Planning and Zoning Commission

SUBJECT:	ACTION REQUIRED:
Consider recommending approval of the Final Plat for Crosshaven Plat 4 subdividing 23.69 acres into 31 single family lots and two outlots. The subject property is located north of Valley Parkway and east of NW 100 th Street.	<input checked="" type="checkbox"/> Ordinance <input type="checkbox"/> Resolution <input type="checkbox"/> Approval <input type="checkbox"/> Receive/File <input type="checkbox"/> Attorney Review

CROSSHAVEN PLAT 4 FINAL PLAT

<p>SUBJECT:</p> <p>Consider recommending approval of the Final Plat for Crosshaven Plat 5 subdividing 13.85 acres into 23 single family lots, a public park lot and two outlots. The subject property is located north of Valley Parkway and east of NW 100th Street.</p>	<p>ACTION REQUIRED:</p> <p><input checked="" type="checkbox"/> Ordinance <input type="checkbox"/> Resolution <input type="checkbox"/> Approval <input type="checkbox"/> Receive/File <input type="checkbox"/> Attorney Review</p>
---	--

DRAWING NO. FP-04 SHEET NO. 01/03

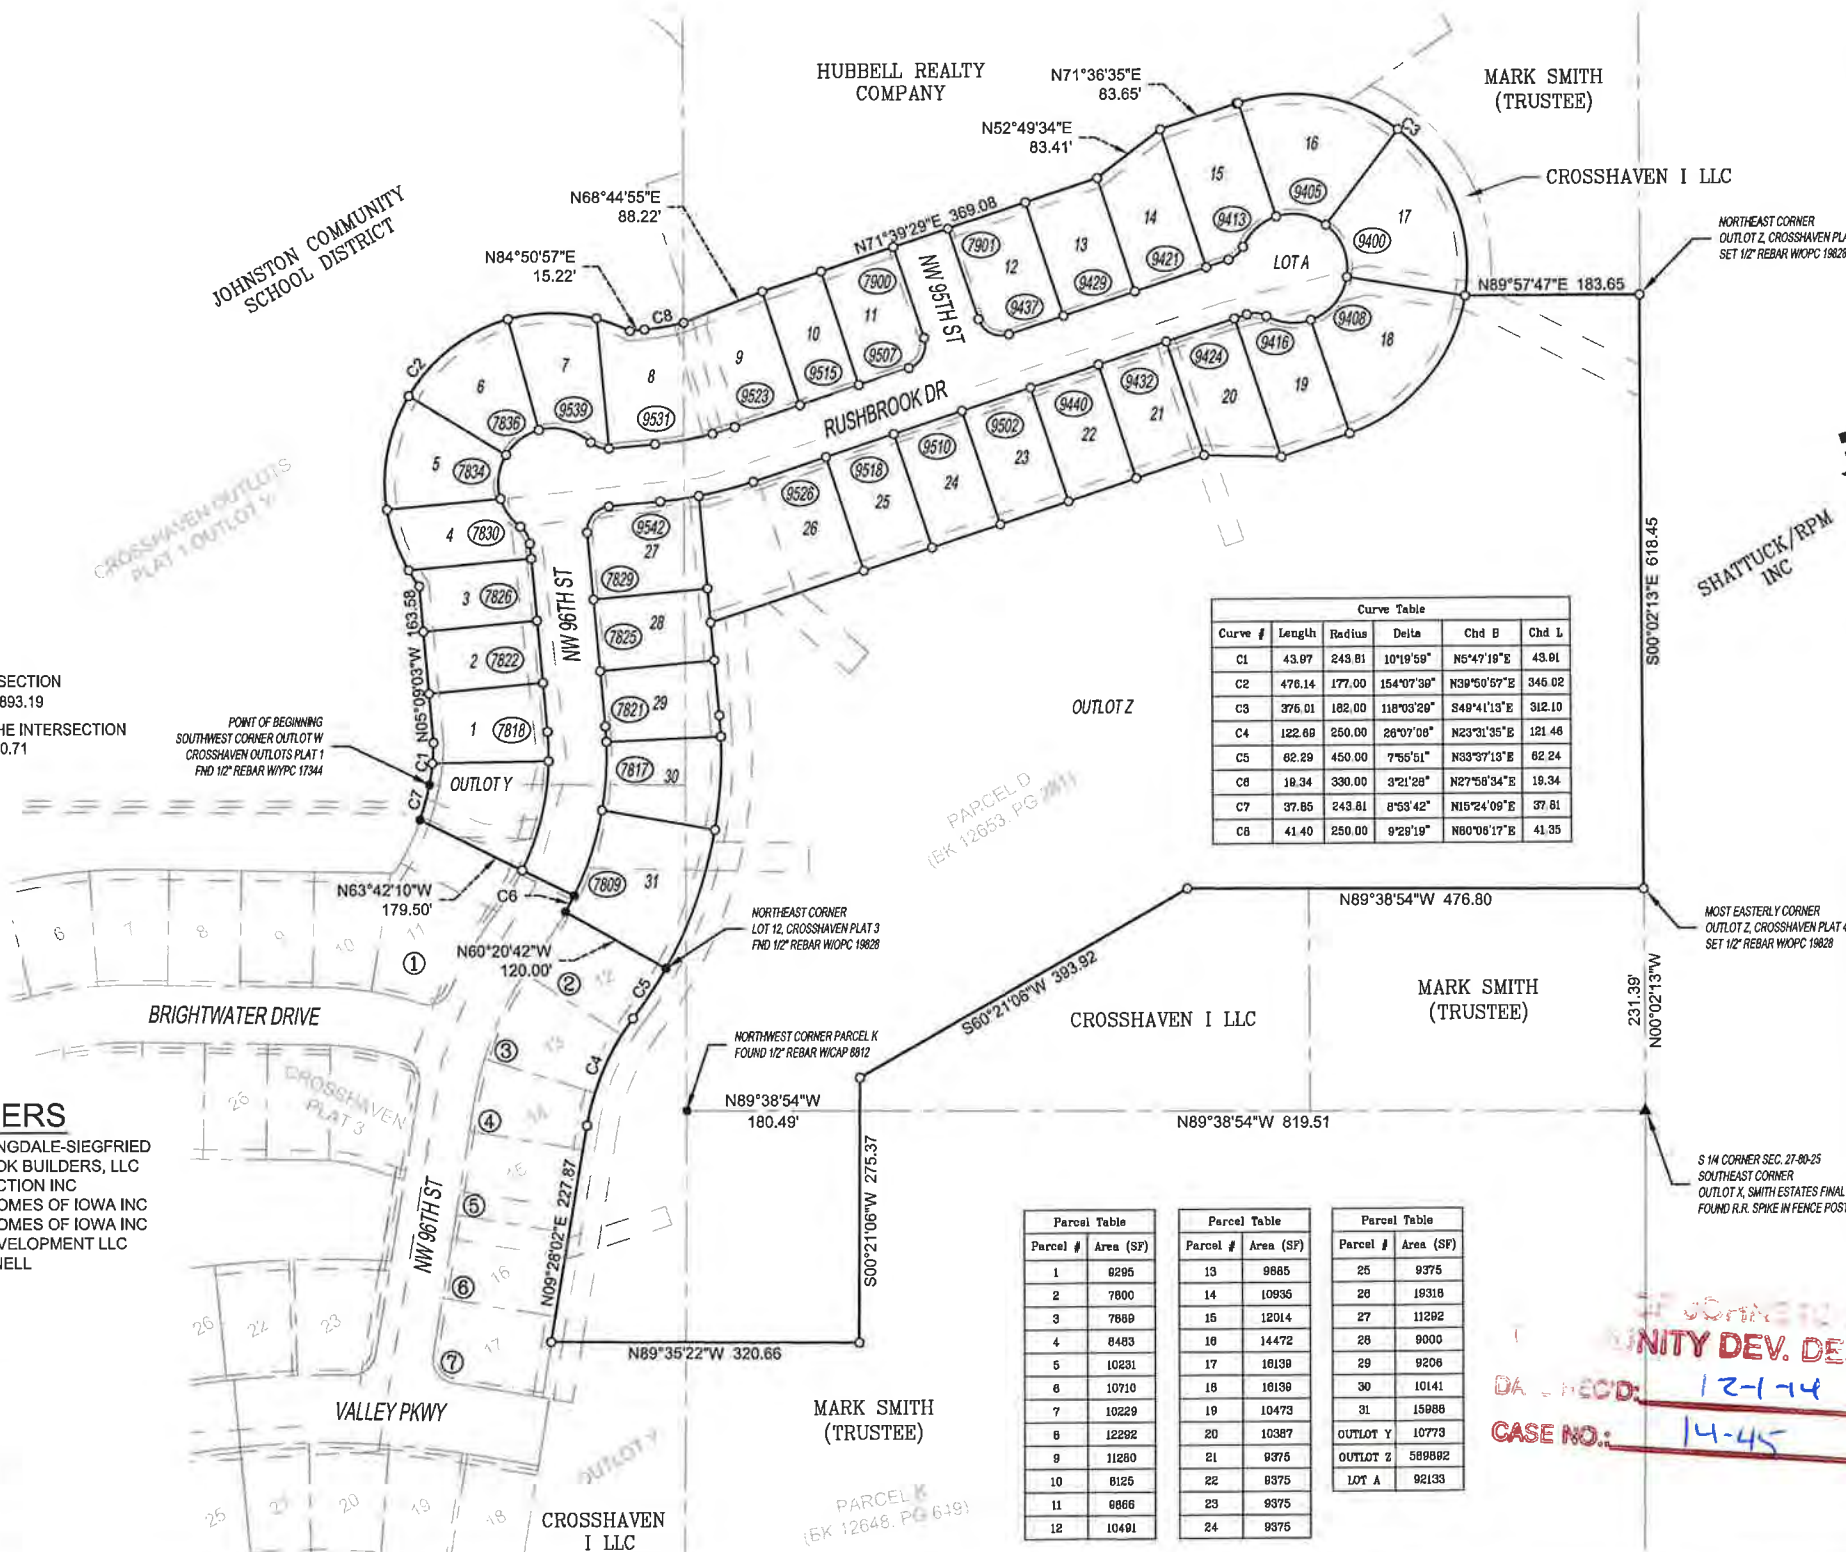
9. Depict overland flowage and storm sewer easements across the drainage pond located within Outlot Z.
10. Address any outstanding comments provided by Foth Infrastructure and Environment, LLC.
